**Town of Groveland**  
**Economic Development**  
**Planning & Conservation Department**  
**Planning Board**  
183 Main Street  
Groveland, MA 01834

**CONTINUED 181R SCHOOL STREET:**

APPLICATION FOR APPROVAL OF  
A DEFINITIVE PLAN

SUBDIVISION NAME 181R School Street PLAN# \_\_\_\_\_

REVISIONS			DRAWING NO. <b>C-3</b>
NO.	DESCRIPTION	DATE

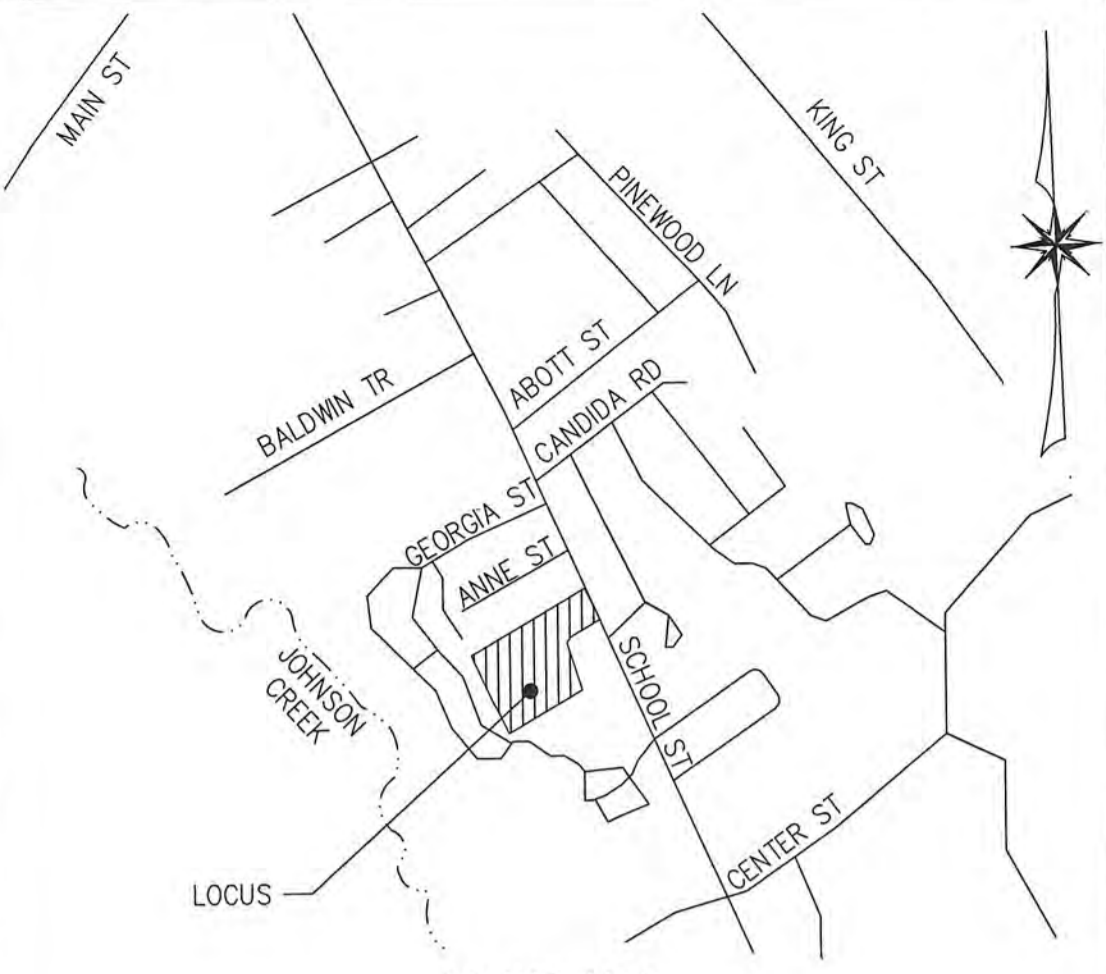
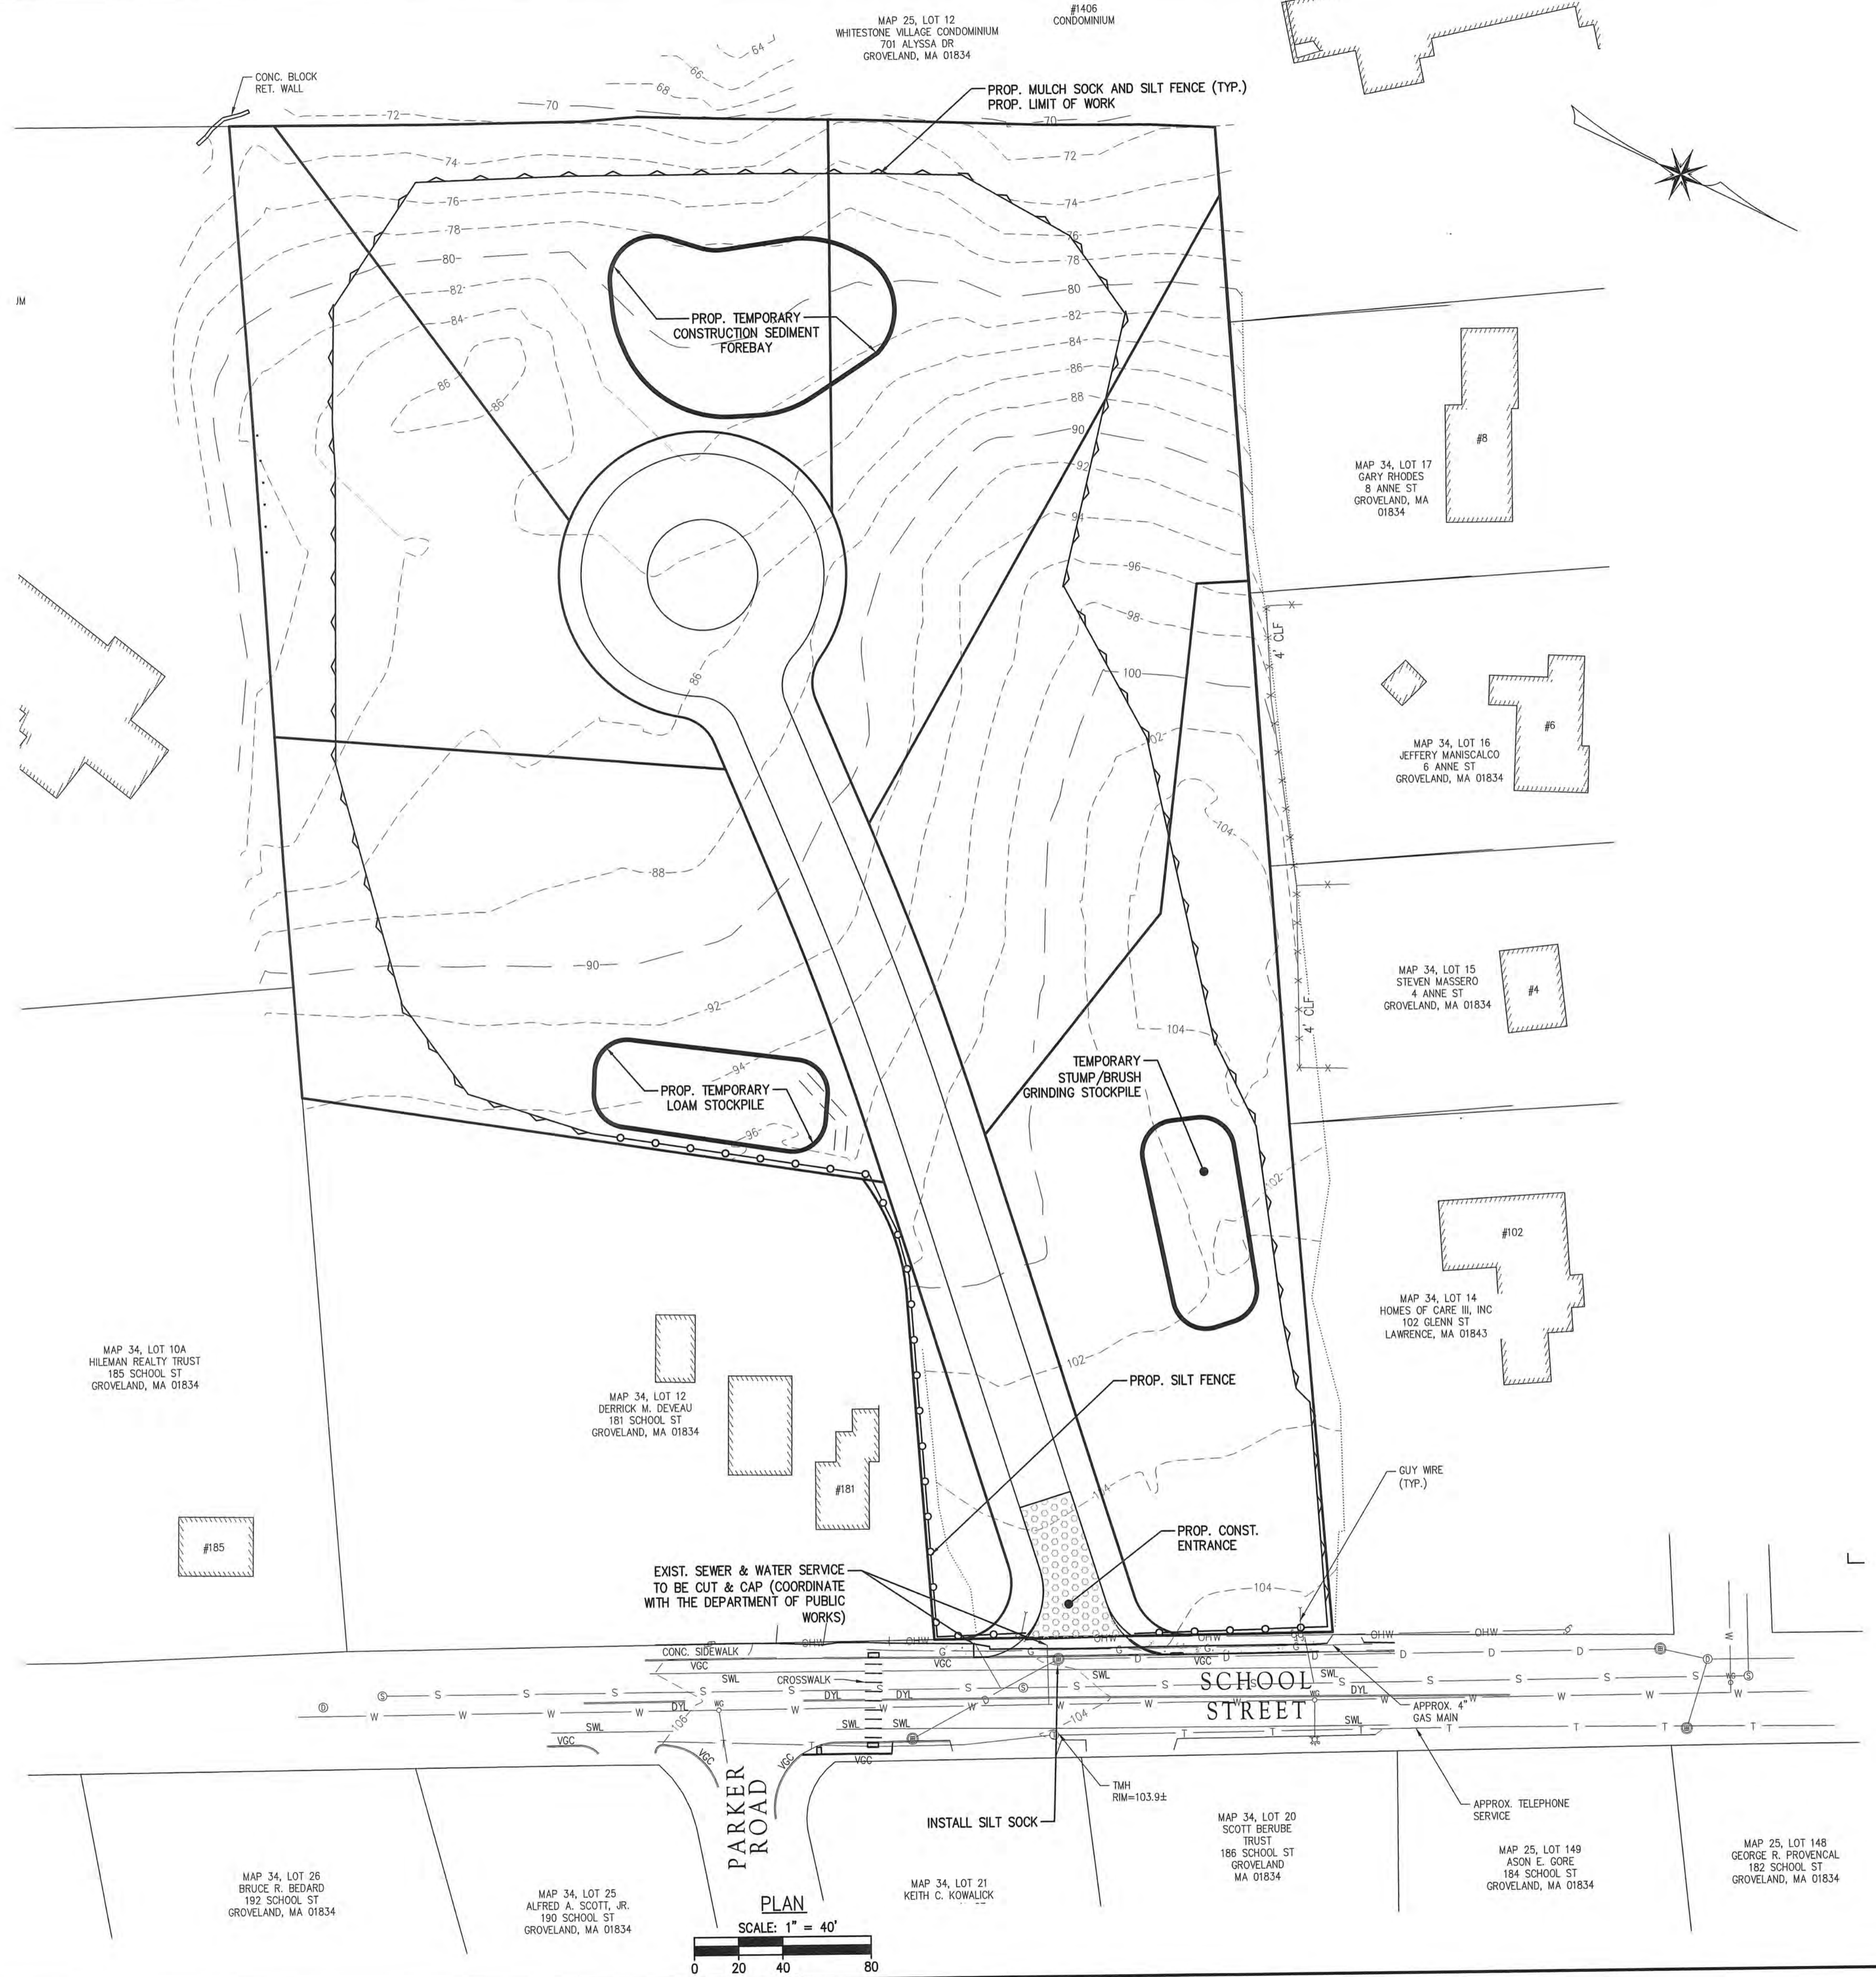
1. **50.8.2** – The lot regularity calculations provided on Sheet C-3 do not include Parcel A. Parcel A should be added to this table. Considering Parcel A is detailed as a non-buildable lot, the applicant should specify the intended owner of this parcel (i.e. a neighboring parcel, the Town of Groveland, etc.).

29. TEC recommends adding the title of Sheet C-3 to the title block for clarity.

REVISIONS			DRAWING NO.
NO.	DESCRIPTION	DATE	
			C-6

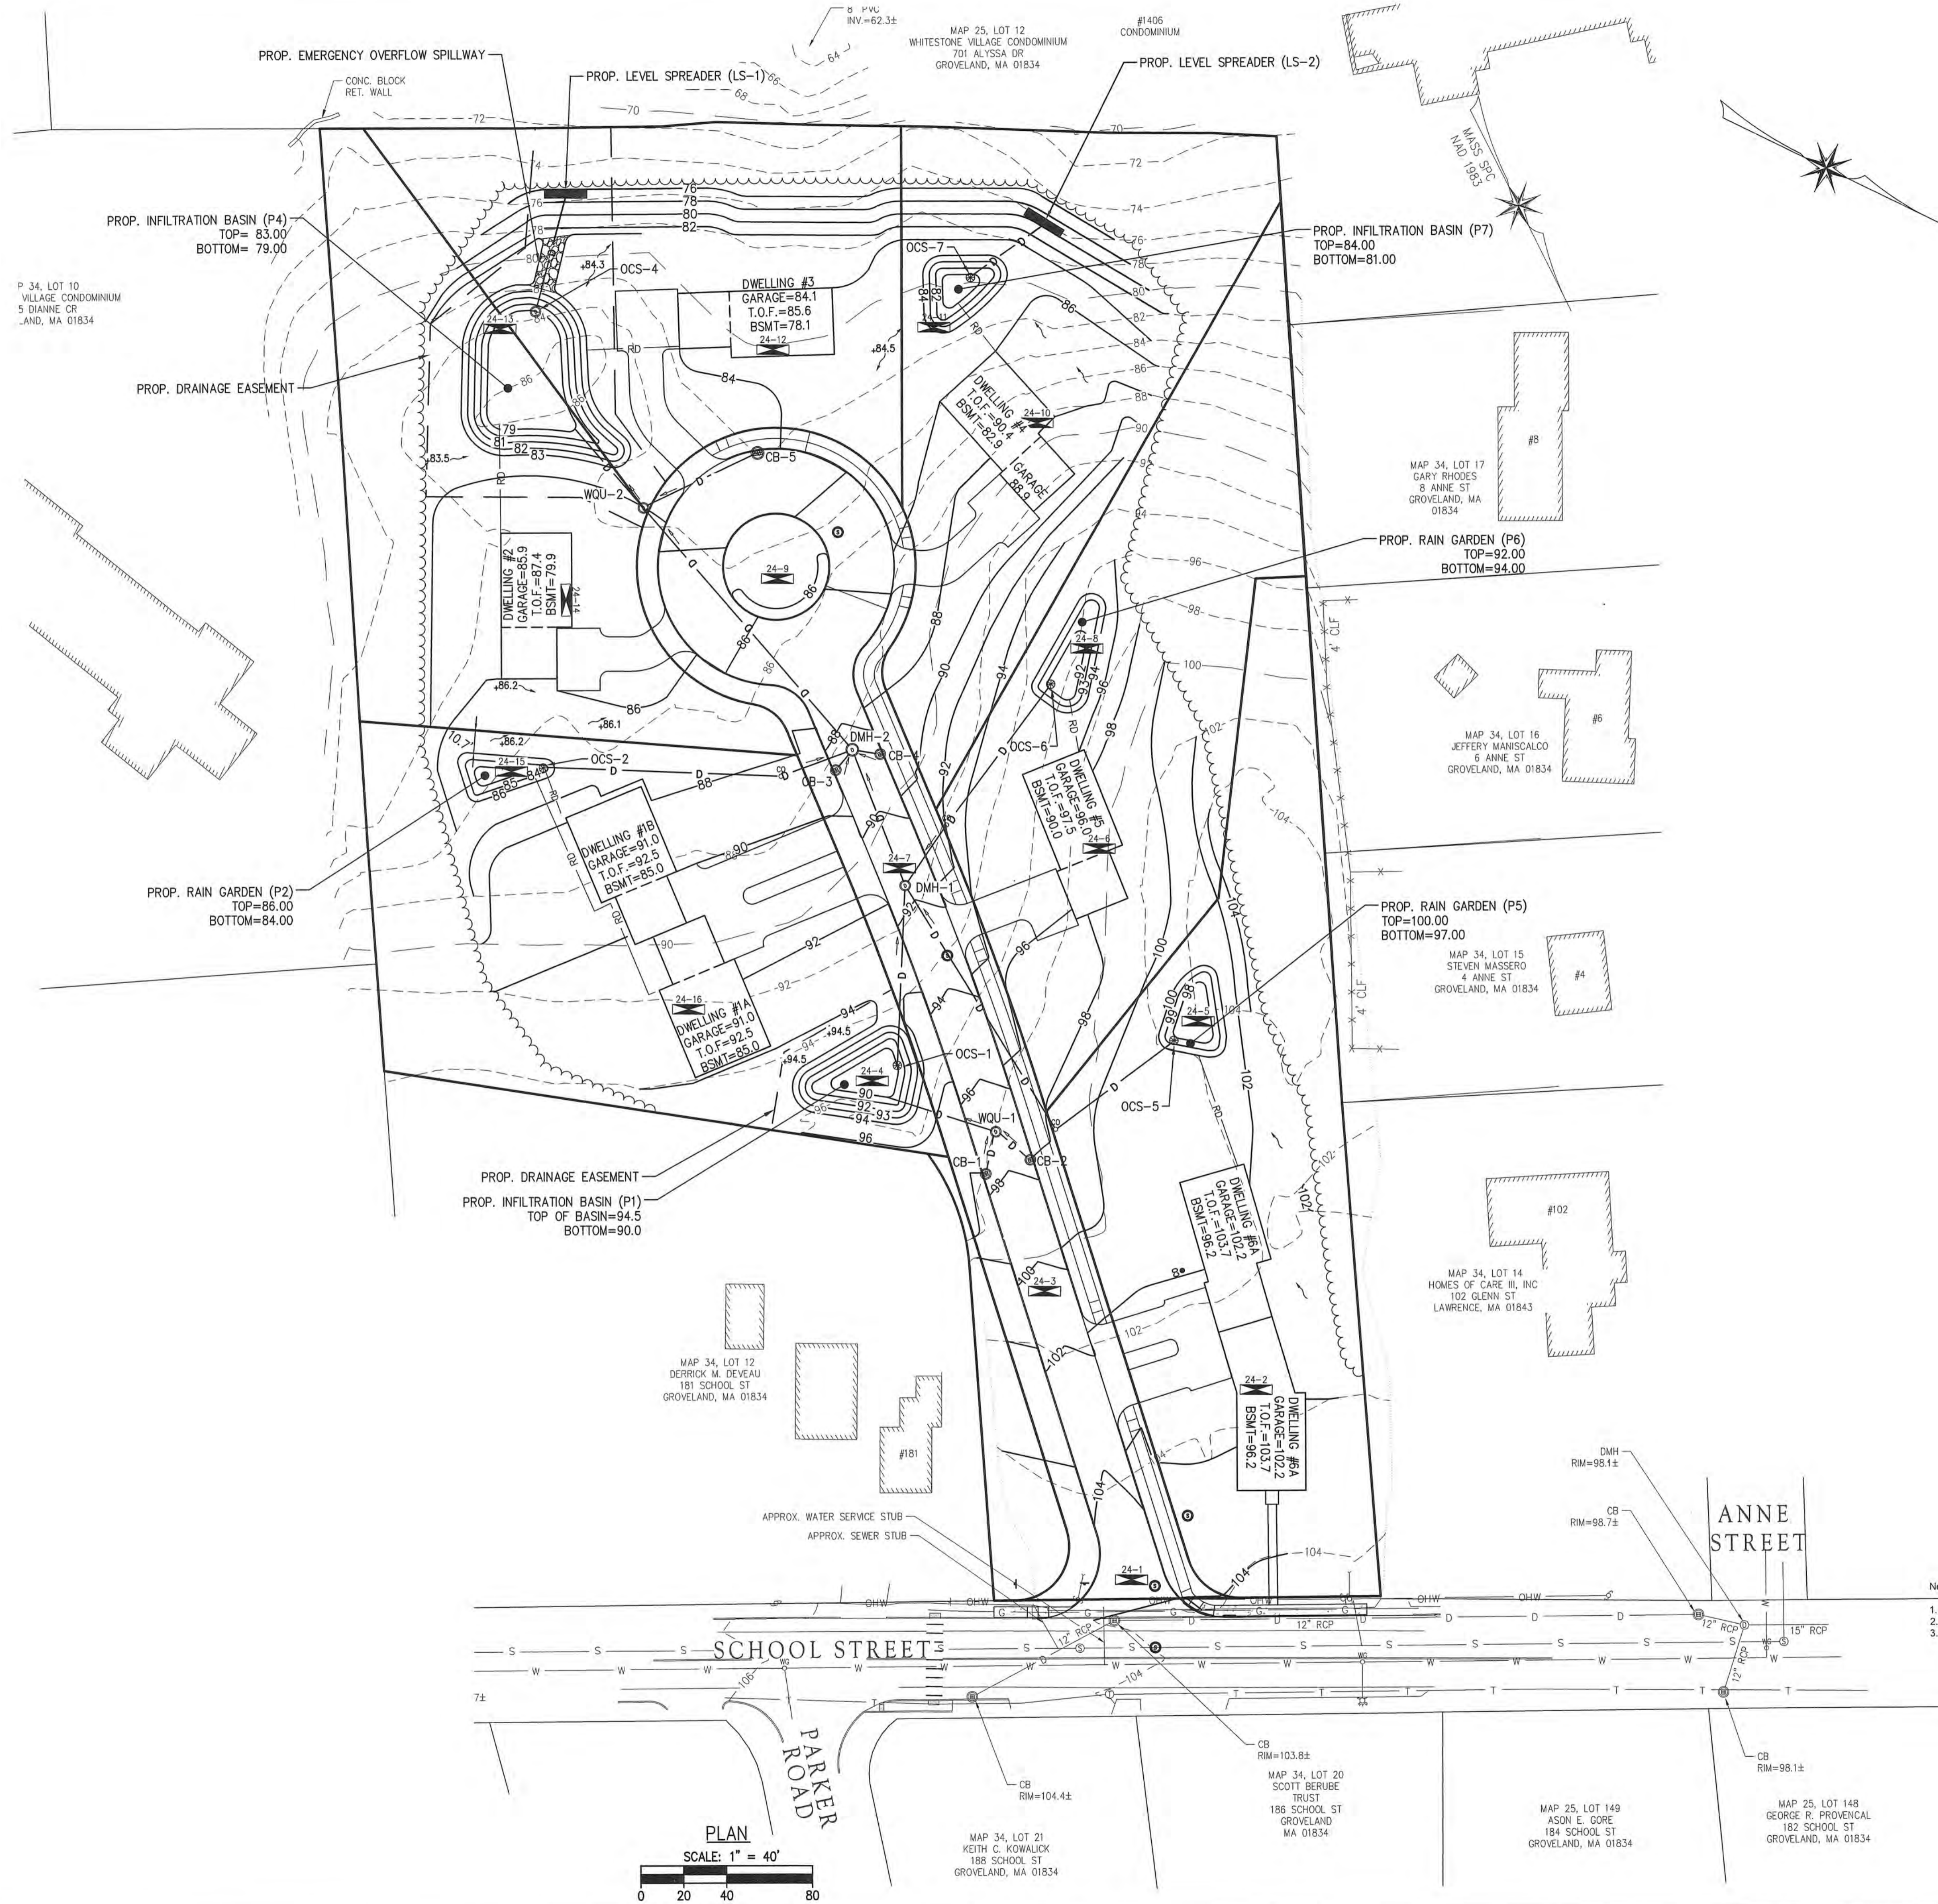
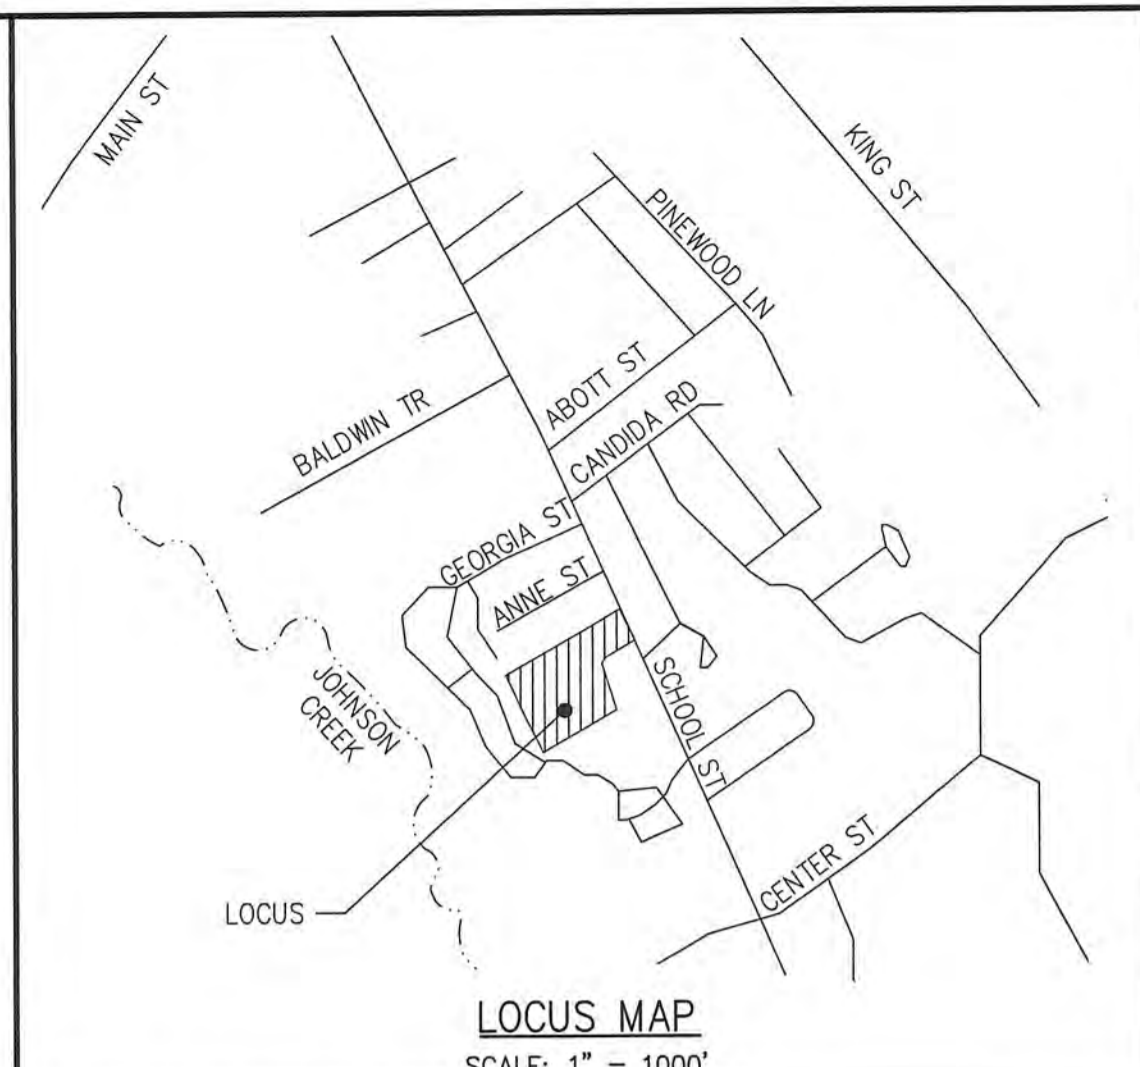
13. **14.10.C.16** – The proposed drainage area of leading to DP-1 does not appear accurate given the proposed grading and roadway layout seen on sheets C-6 and C-7. The applicant should revise their plans and associated calculations accordingly.

- c. On Sheet C-6, The bottom contour (elevation 97) appears to be missing from rain garden P5.
  - d. On Sheet C-7, there is no label detailing the proposed rim or invert elevation(s) for proposed catch basin 2 (CB-2).
